Fargo VAMC – Refurbish Elevators and Replace Controls

Fargo, North Dakota
Project #19-2481

MARCH 26, 2024

ADDENDUM NO. 2

4 FLOOR PLAN - INDEPENDENCE 4,5 - DEMOLITION TYPICAL
1/4" = 1'-0"

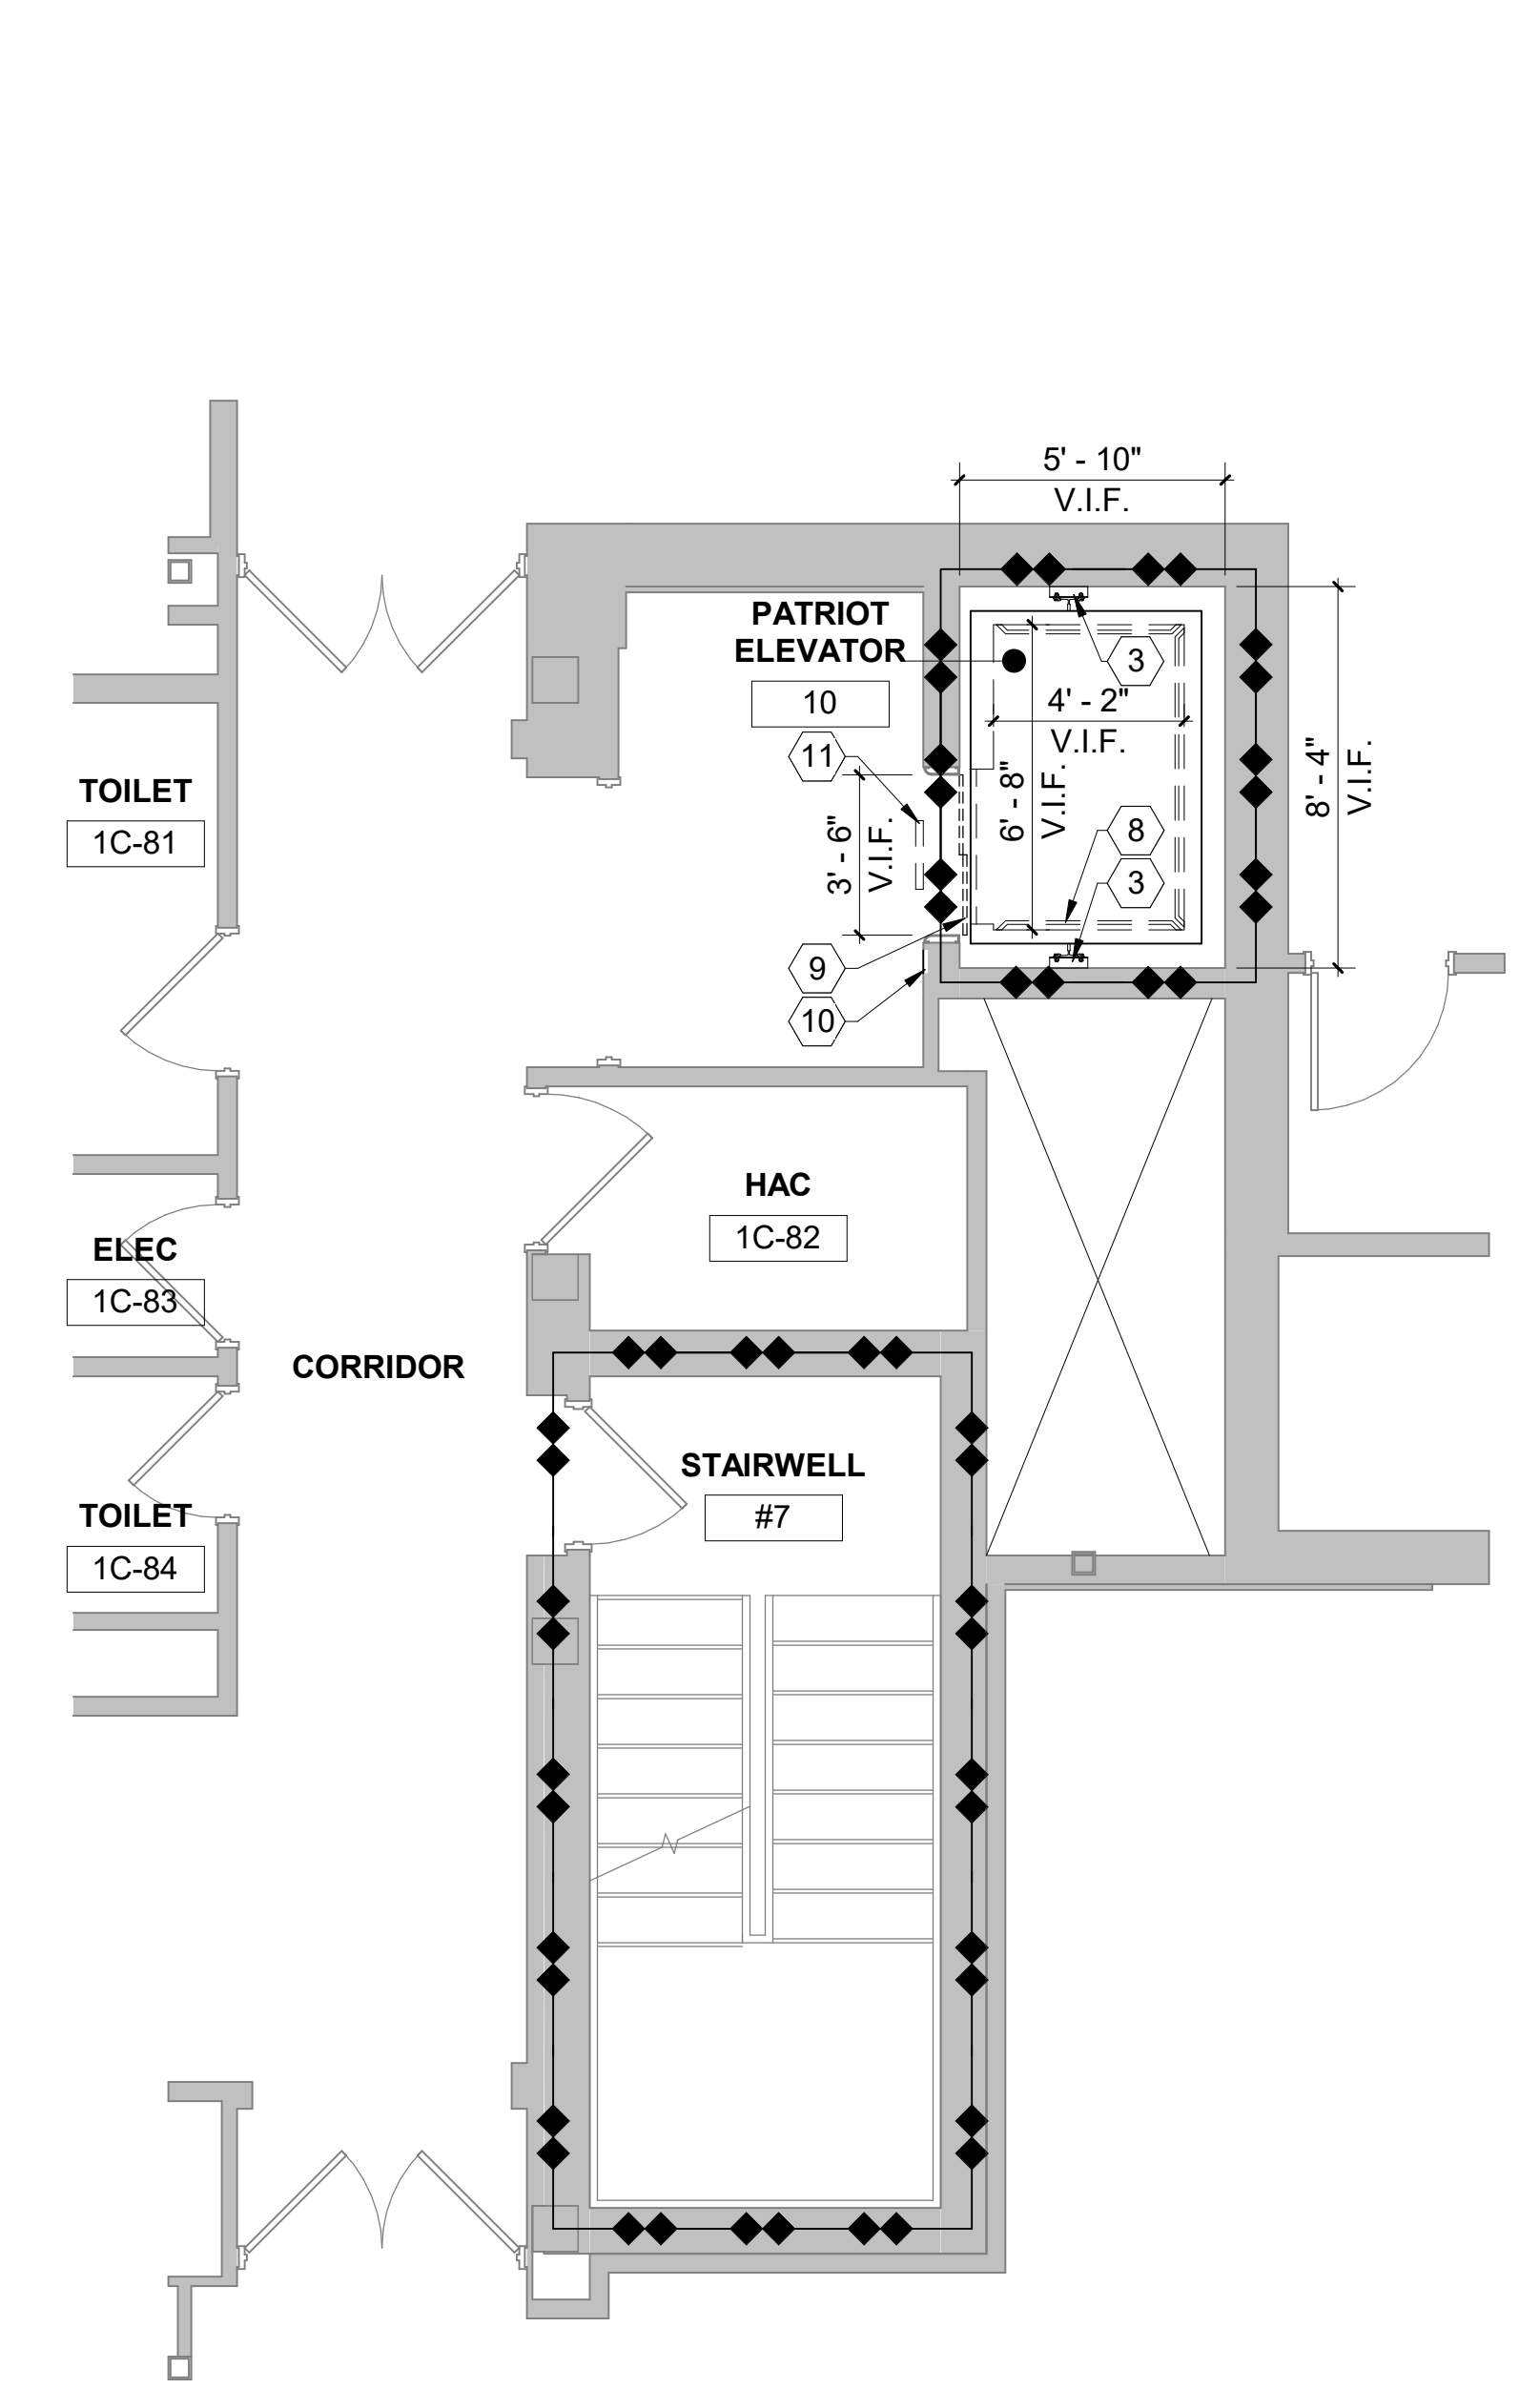
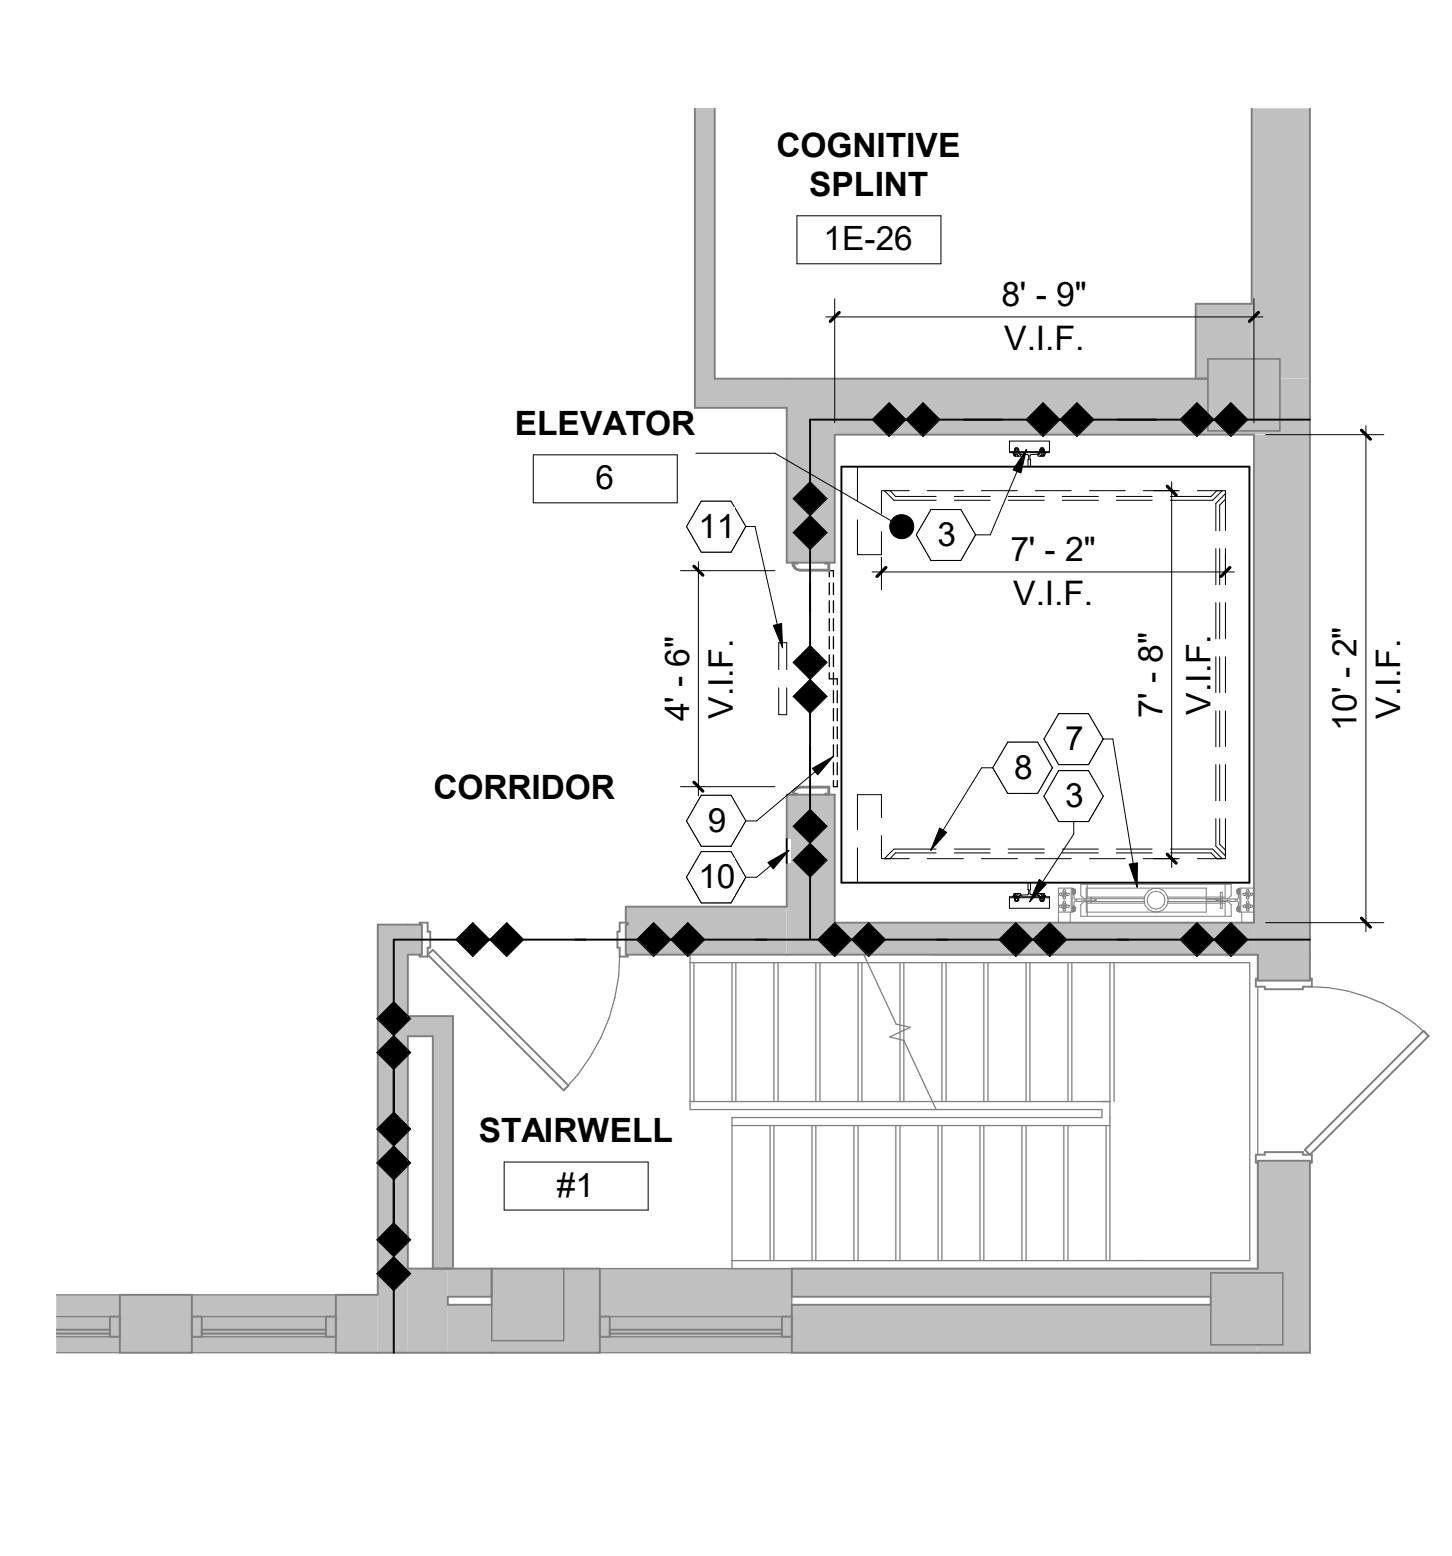
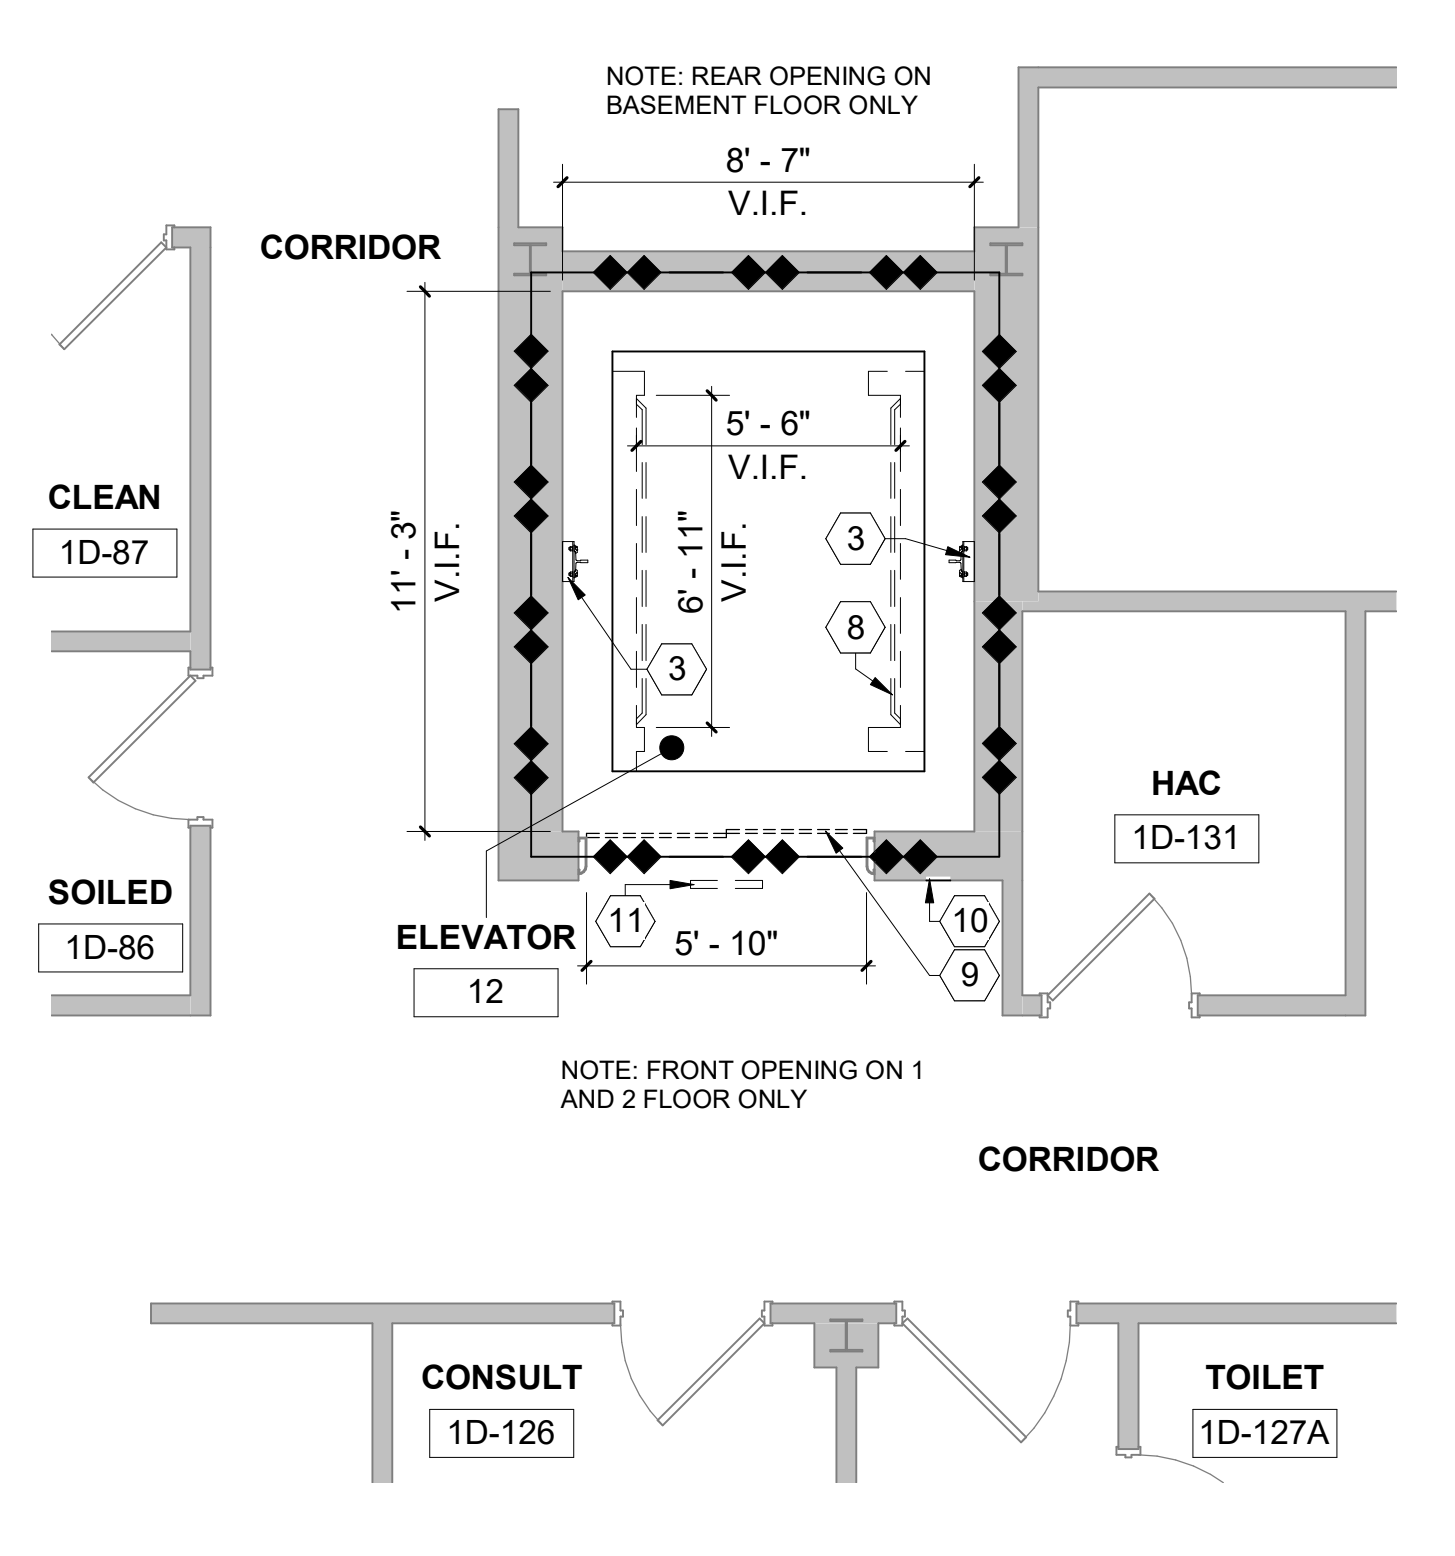
Drawing Sheet AD5.21 ENLARGED PLANS - DEMOLITION – See revised drawing sheet for the adjustment of keynotes # 3, 9, 14, 15.

13. NOT USED.
14. REPLACE EXISTING LOWER SECTION OF COUNTERWEIGHT ASSEMBLY GUIDERAILS IN ELEVATOR 7 AND 8 (APPROX 20 LF AT EACH RAIL). BALANCE COUNTERWEIGHT AS REQUIRED.

15. REPLACE LOWER SECTION OF EXISTING GUIDE RAILS (APPROX 20LF AT EACH RAIL) DUE TO WATER DAMAGE. APPLIES TO ELEVATOR 7 AND 8 ONLY.
